SERVICE ACTION: REPLACE ACTIVATED CHARCOAL FILTER AND NVLD SENSOR HOLDER

This Service Information bulletin replaces SI B16 01 17 **dated February 2017**

F25 (X3)	F26 (X4)
----------	----------

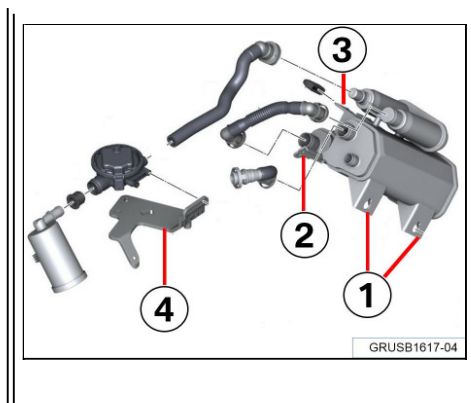
The activated charcoal canister and or NVLD sensor holder may be damaged.

Transportation damage.

<ol style="list-style-type: none"> 1. Inspect the mounting brackets (1-3) in the illustration located on the activated charcoal canister.
--	--

Inspect the NVLD sensor holder (4).

Replace activated charcoal canister and NVLD sensor holder if found damaged.

2. Replace the activated carbon canister and the NVLD sensor holder if found cracked or deformed.
